STATE OF NORTH CAROLINA
DEPARTMENT OF TRANSPORTATION

SUBJECT: Request for Modification of the Phased Section 404 Individual Permit and Section 401 Individual Water Quality Certification, Neuse River Riparian Buffer Authorization for the construction of the Triangle Expressway Southeast Extension from NC-55 Bypass in Apex to I-40, Wake and Johnston Counties. TIP Nos.: R-2721, R-2828, and R-2829. Federal Aid Project No. 0540047.

PERMIT DRAWING
SHEET 1 OF 112

WETLAND AND SURFACE
WATER IMPACTS PERMIT

PERMIT DRAWING
SHEET 36 OF 112

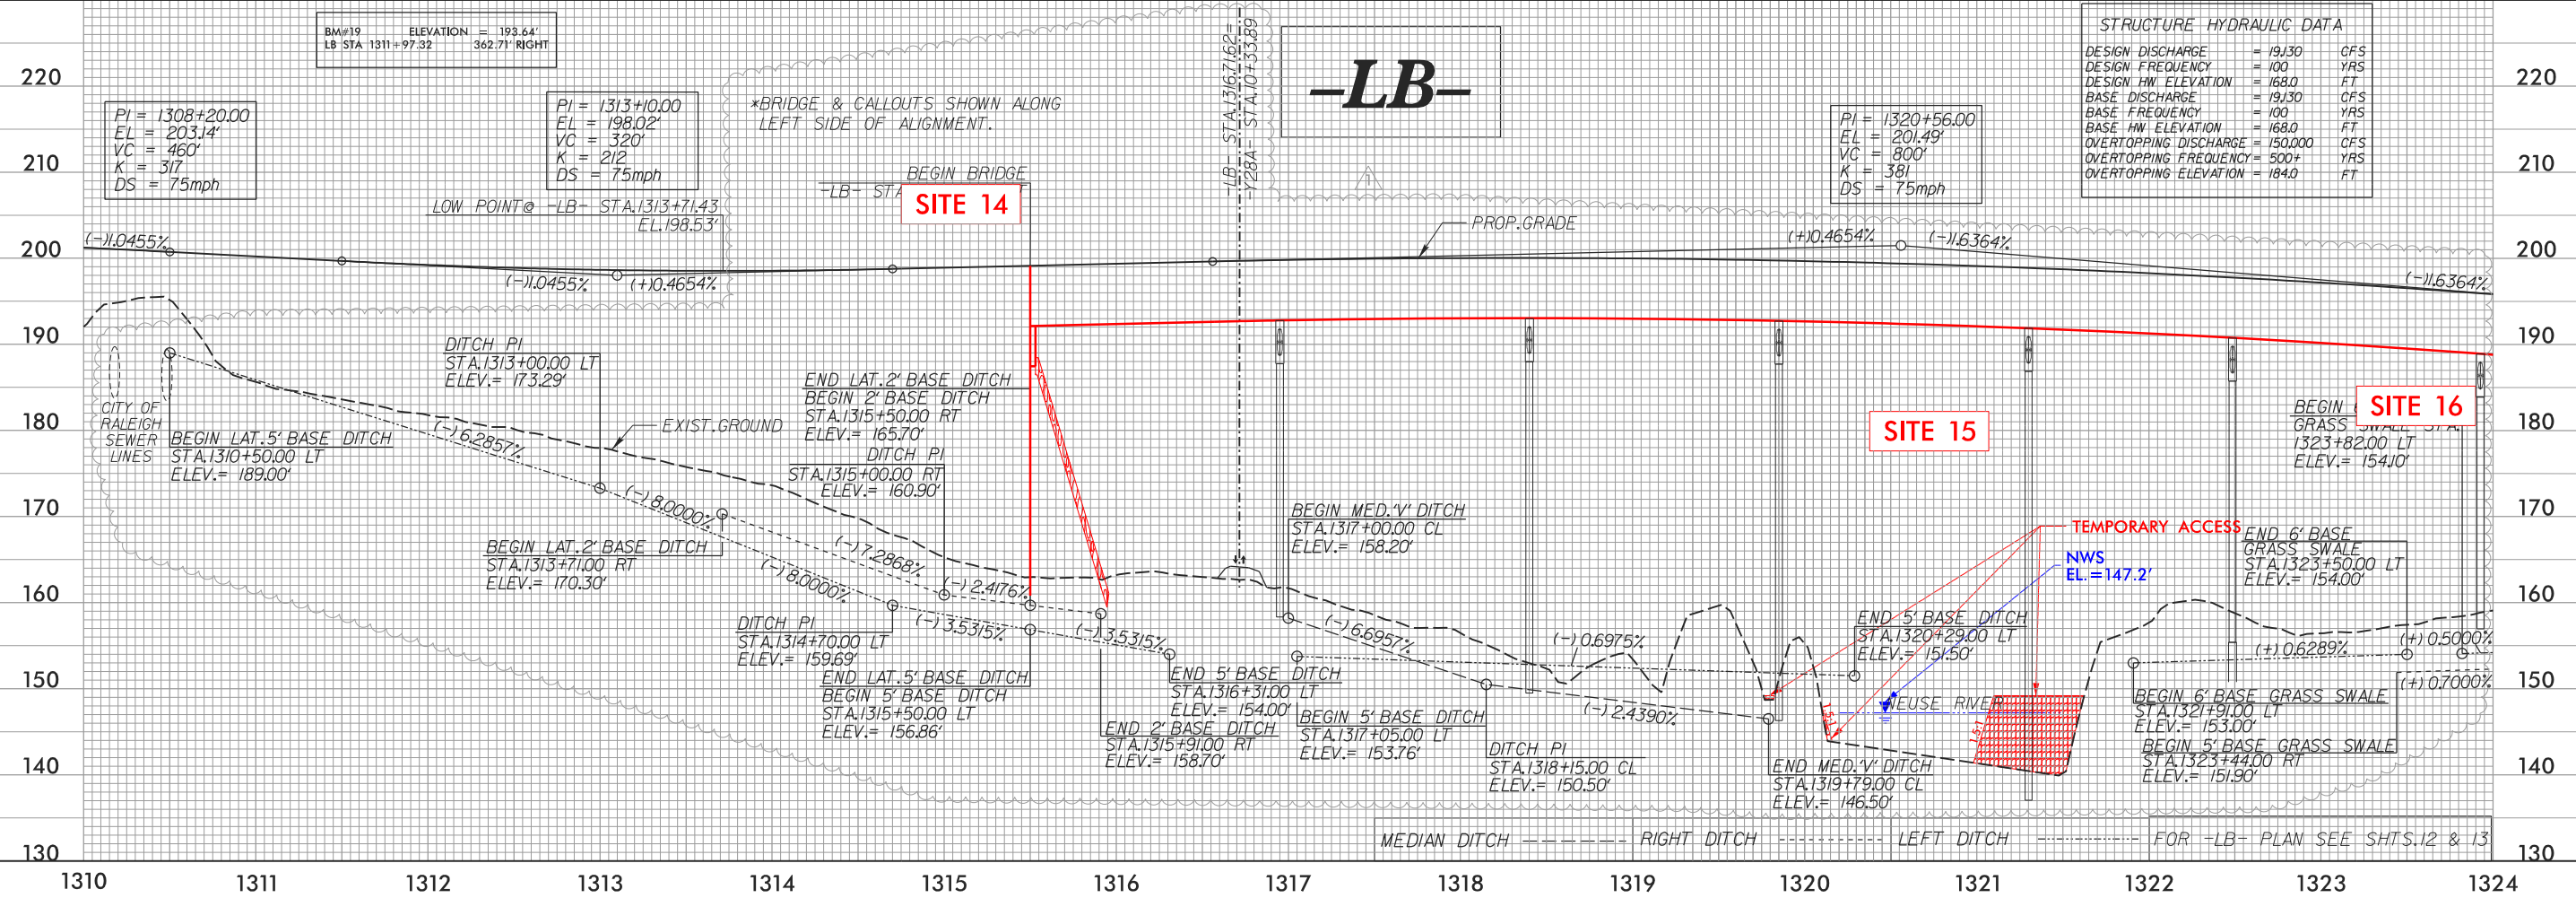
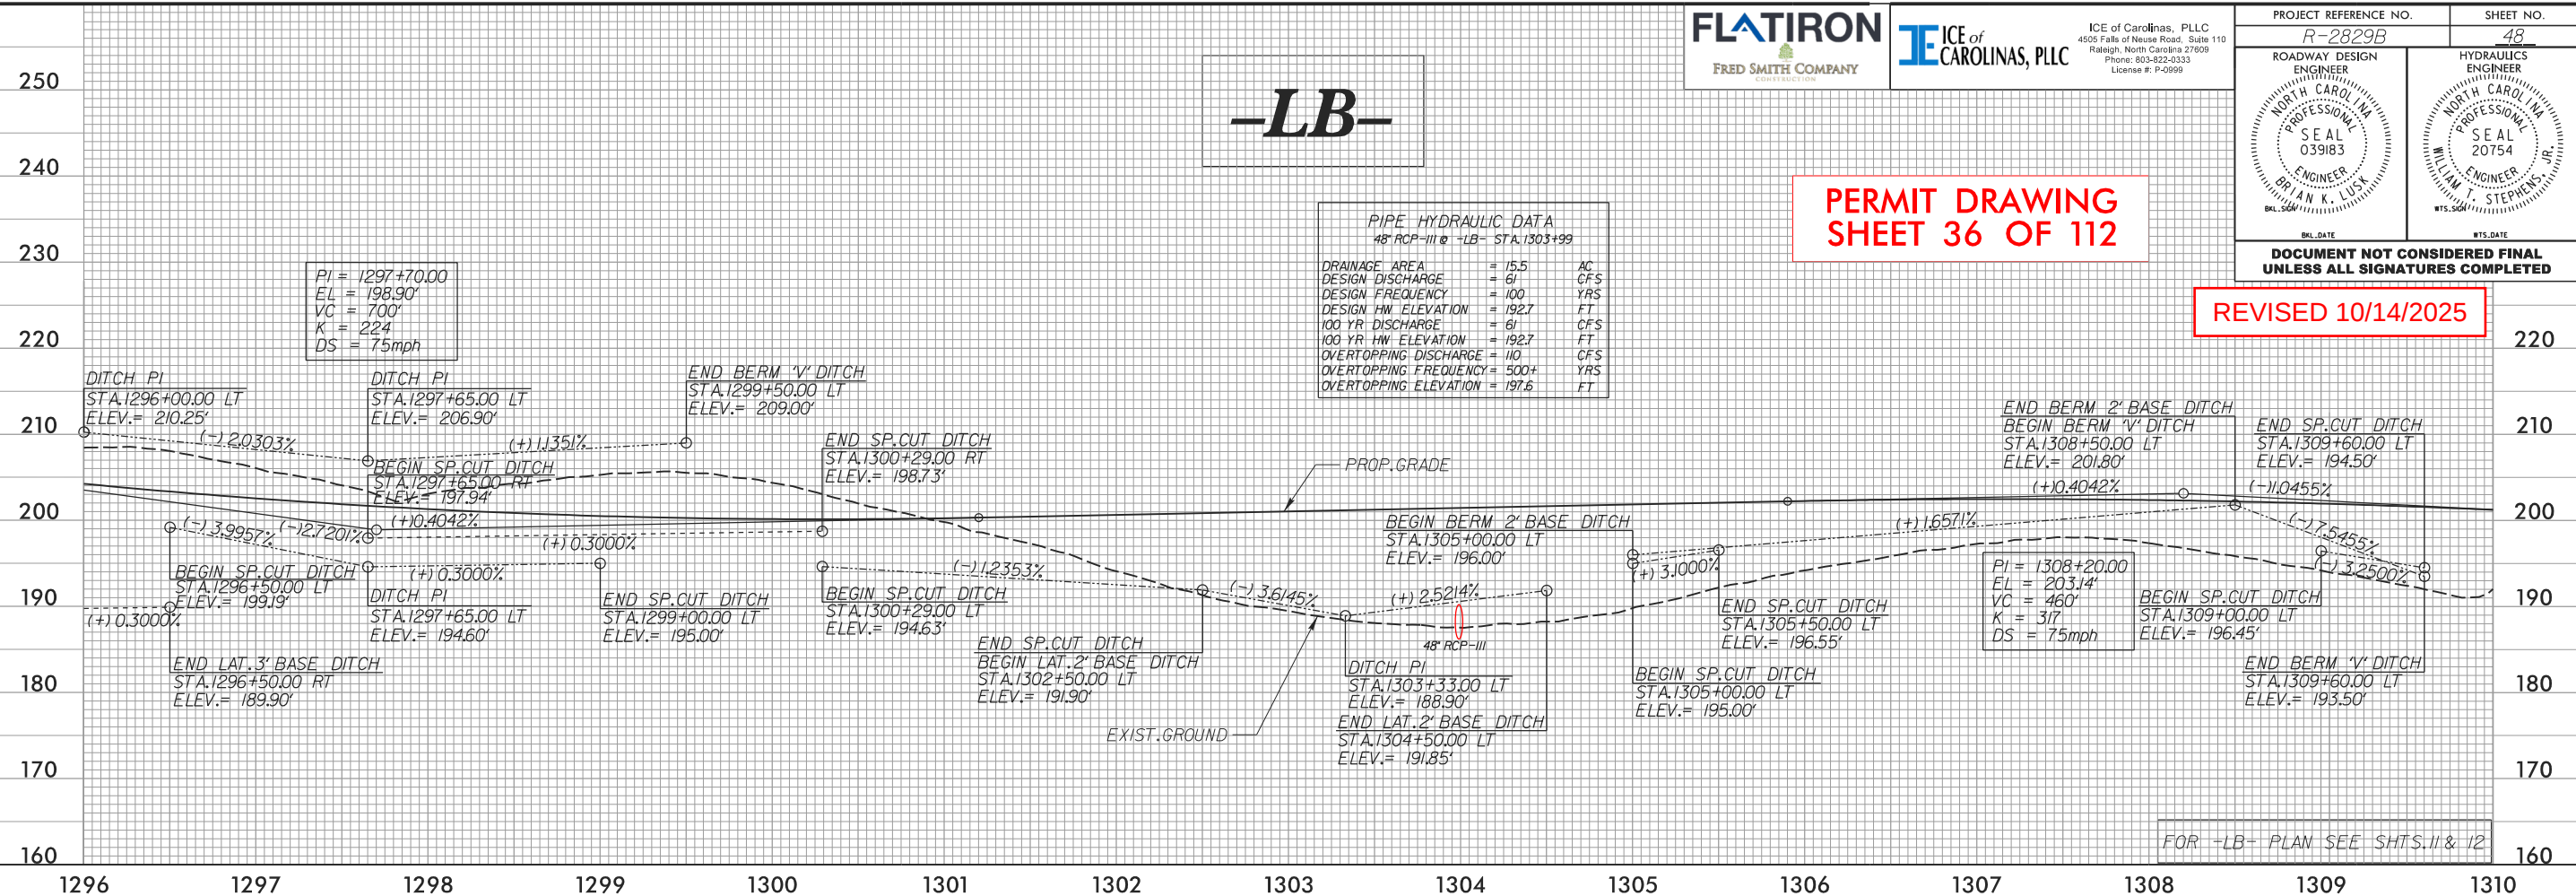
5/12/2025: UPDATED BRIDGE STATION CALLOUTS AND DITCH PROFILES FOR NEUSE RIVER BRIDGE REDUCTION.

PERMIT DRAWING
SHEET 37 OF 112

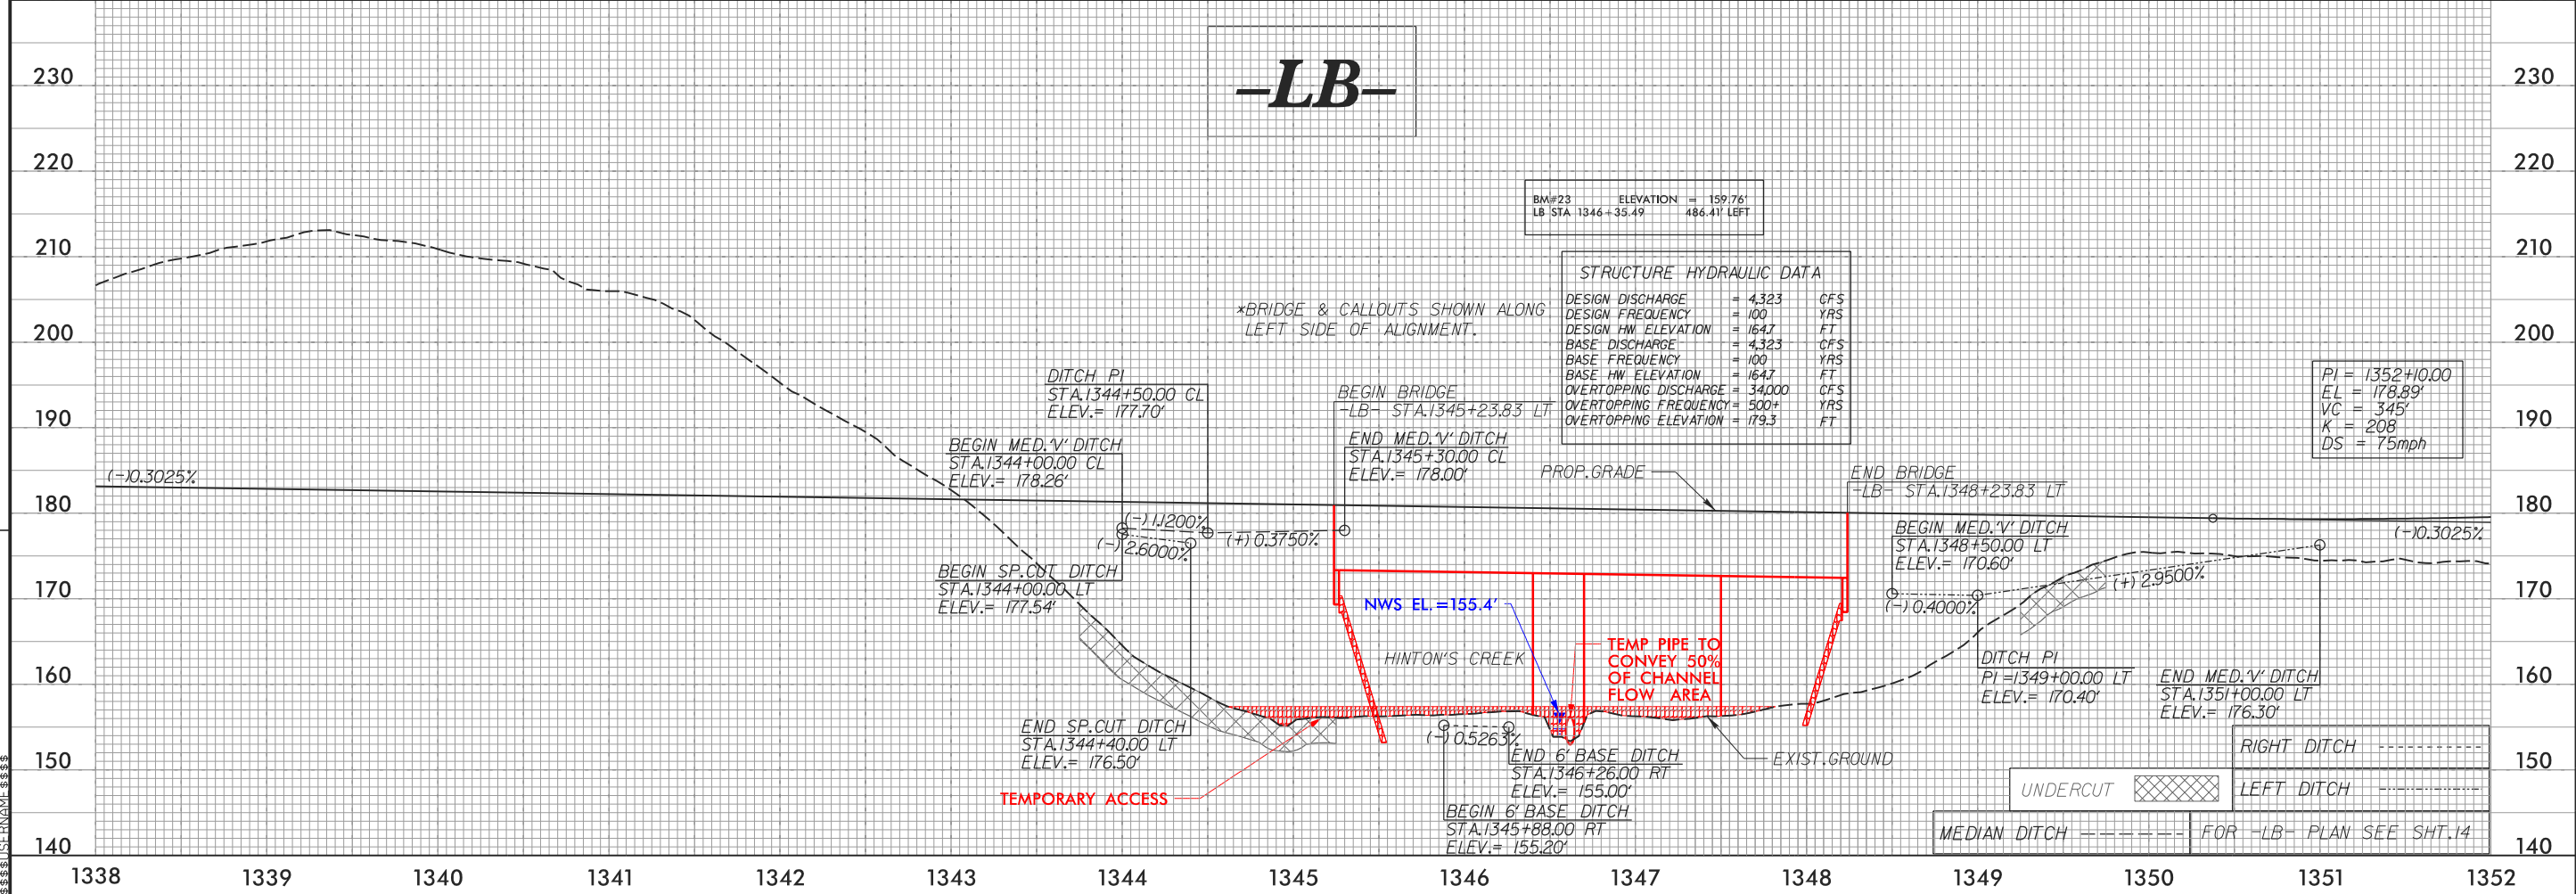
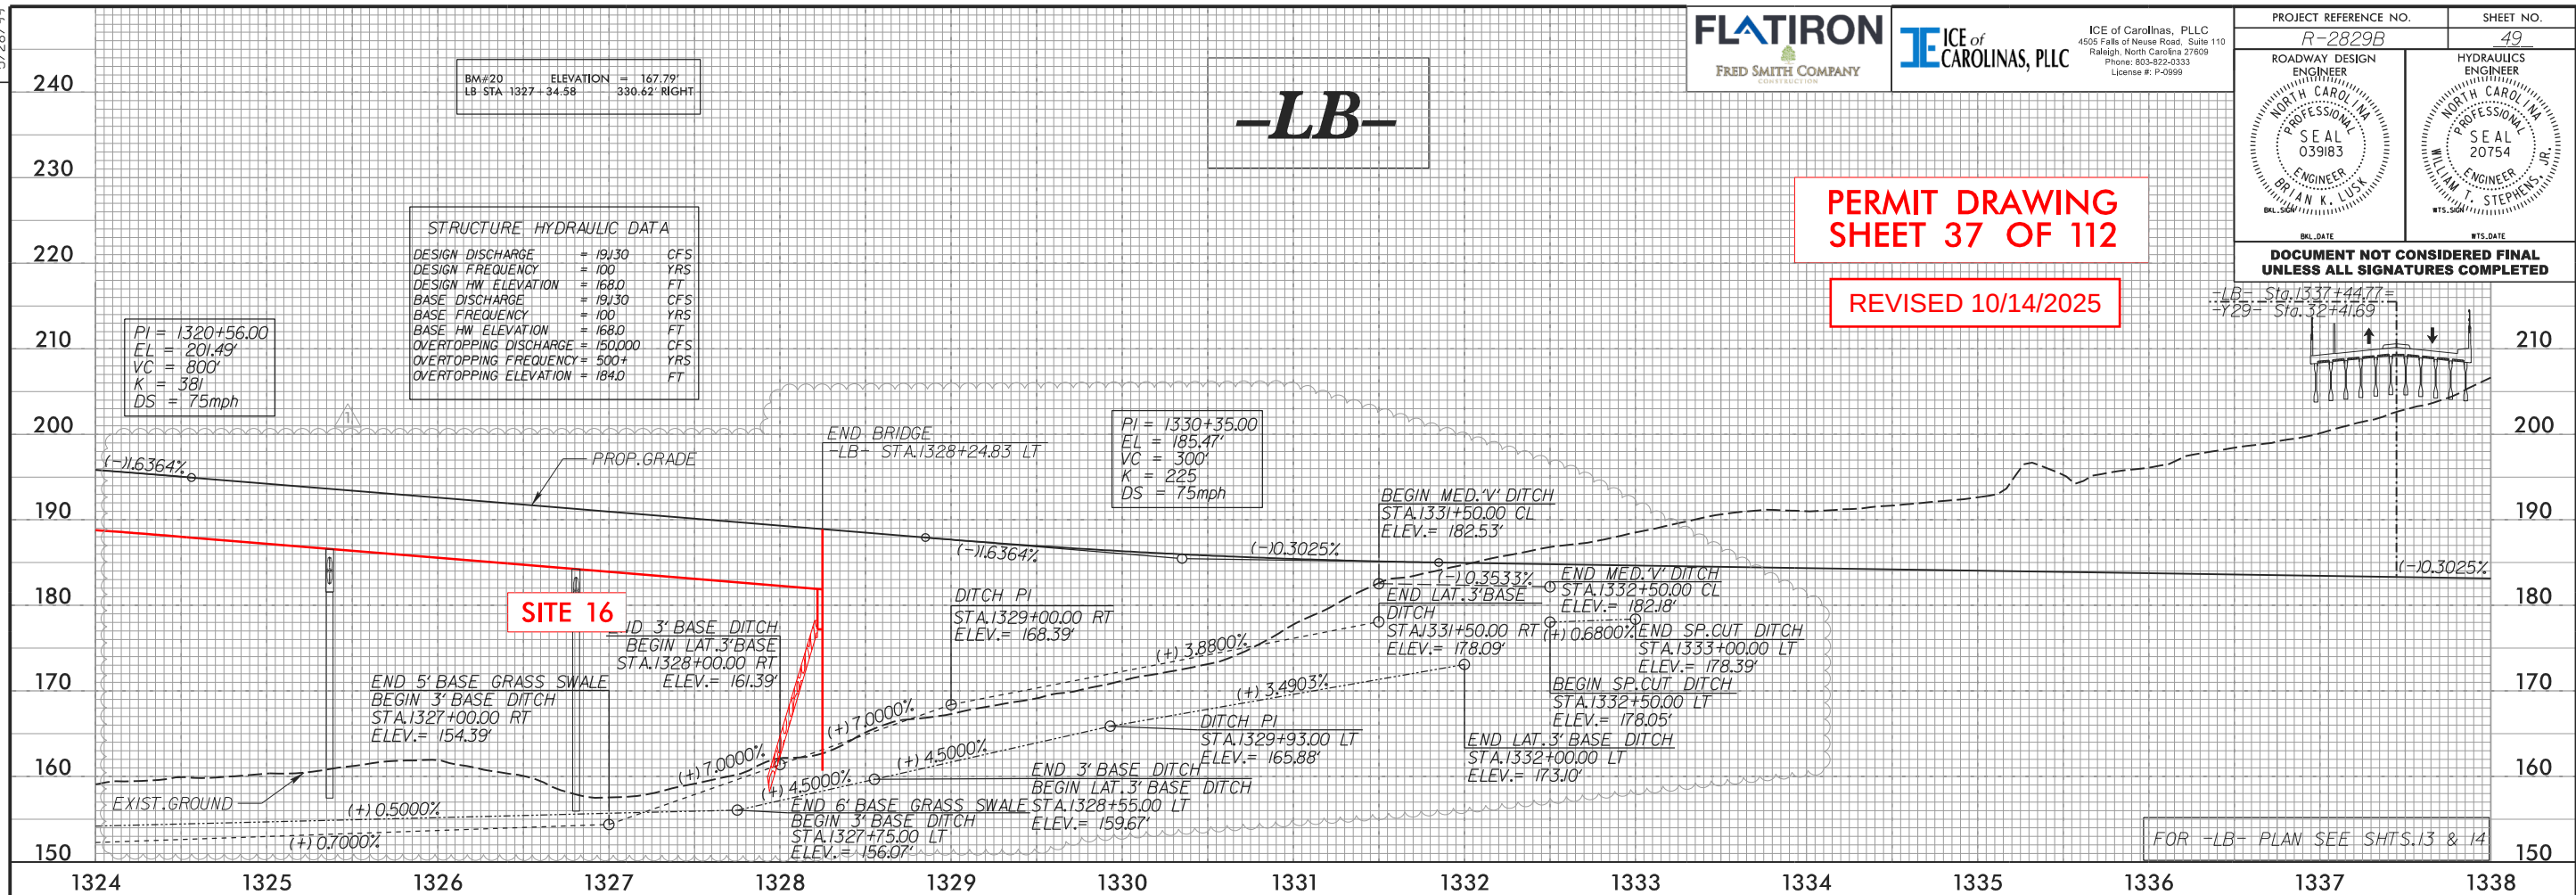
REVISIONS	
5/2/2025:	UPDATED XSC'S OF -LB- STA. 1310+50.00 TO STA. 1333+00.00 TO INCORPORATE DESIGN REVISION OF NEUSE RIVER BRIDGE LENGTH REDUCTION.
